FOXCONN® Foxconn Technology Group Ennoconn Corporation	Ennoconn Corporation Hardware R&D Dept.	
Title	Charger	
Size D	Document Number IPS_70CB	Rev 0.2
Date: Friday, January 18, 2019	Sheet 46 of 49

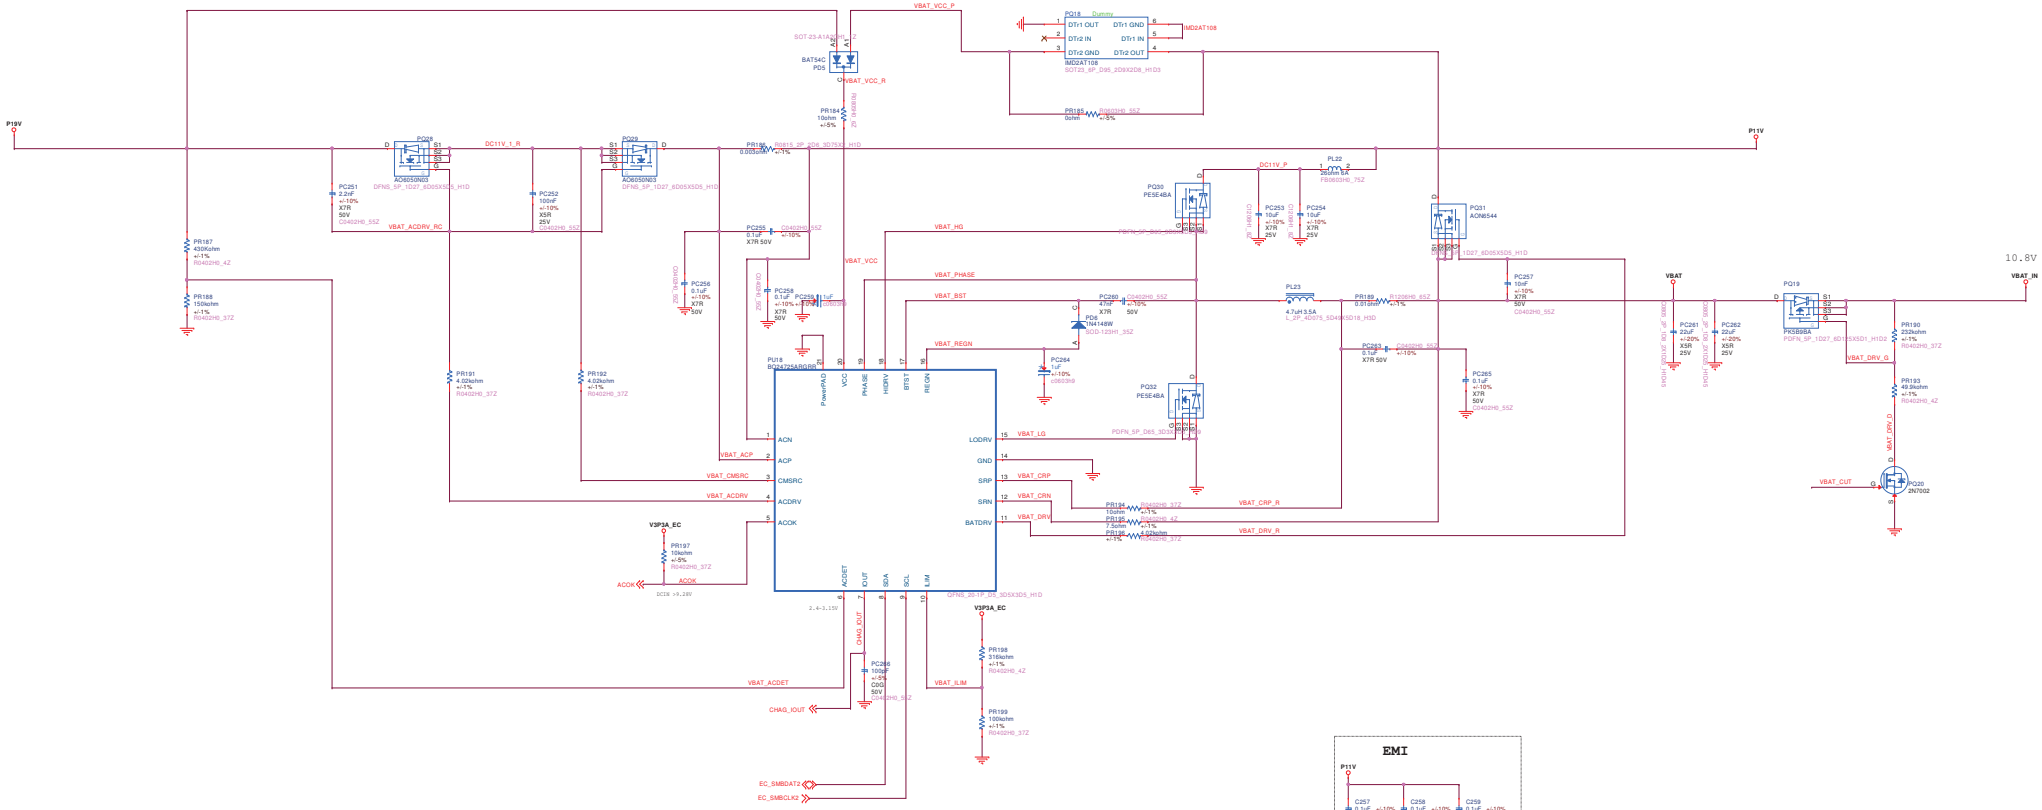
Should check PACK circuit,can remove this circuit if PACK not pull-high and PACK not master.
